## Detailed Site Plan Melford, Block 3, Lots 1 and 2

**DSP-07072-02**

REQUEST	STAFF RECOMMENDATION
Revision to replace two 8,167-square-foot retail buildings with one 10,260-square-foot commercial building, relocate a future pad site, and reconfigure the parking area.	With the conditions recommended herein:  •Approval of Detailed Site Plan DSP-07072-02

SUBJECT:       Detailed Site Plan DSP-07072-02  
                  Type II Tree Conservation Plan TCPII-036-99-18  
                  Melford, Block 3, Lots 1 and 2

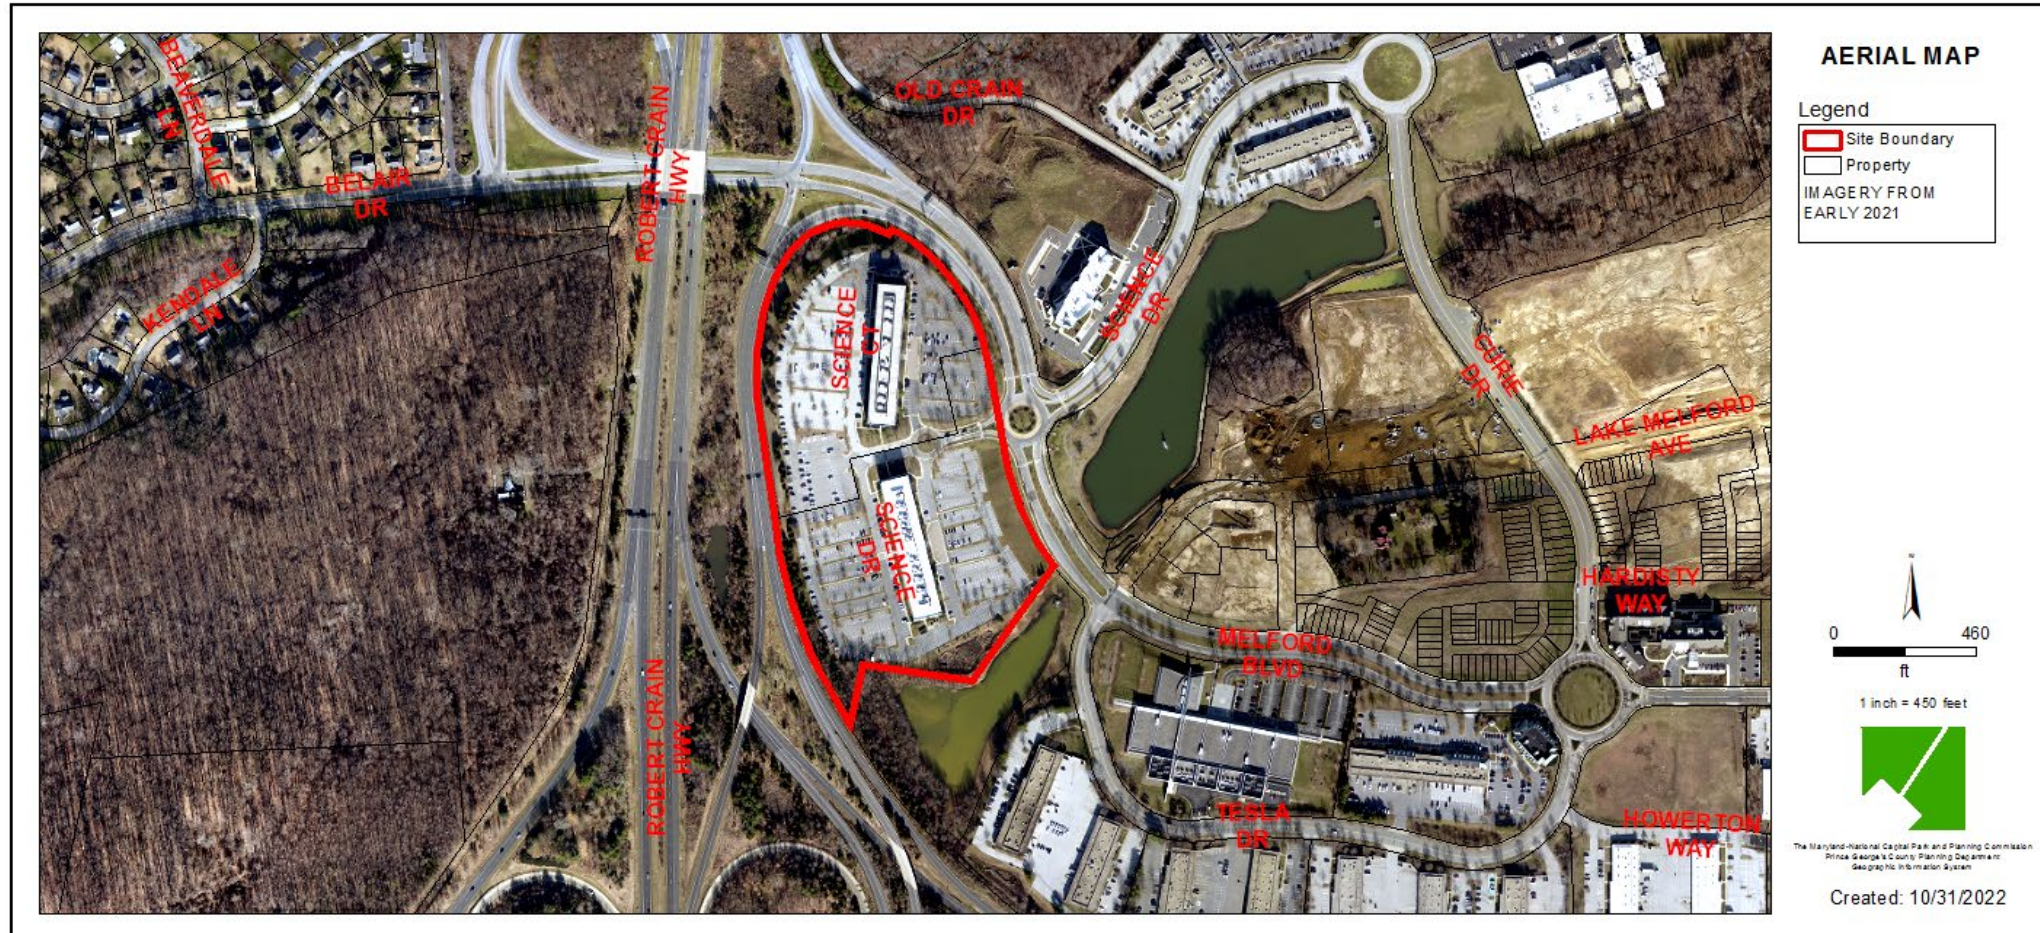
2. Prior to signature approval of the detailed site plan (DSP), the Preliminary Plan to Detailed Site Plan–Comparison Tracking Chart on Sheet C-1A shall be modified as follows:
  - a. Revise Footnote 4 to read:

- b. Revise Footnote 6 to reference DSP-07072-02 instead of DSP-18034-01.
  - c. Add a column for DSP-07072-01 and ensure the columns for DSP-07072-01 and DSP-07072-02 each list the development approved under that amendment.

“The two 150,000-square-foot (each) buildings existing on Parcels 2 and 3, Block 3, as approved with DSP-07072-02, were originally approved under PPS 4-98076. Therefore, these two buildings do not count against the office GFA approved under PPS 4-16006, and thus, are not included in the ‘total’ column. The trip cap associated with this prior development was included as part of 4-16006.”
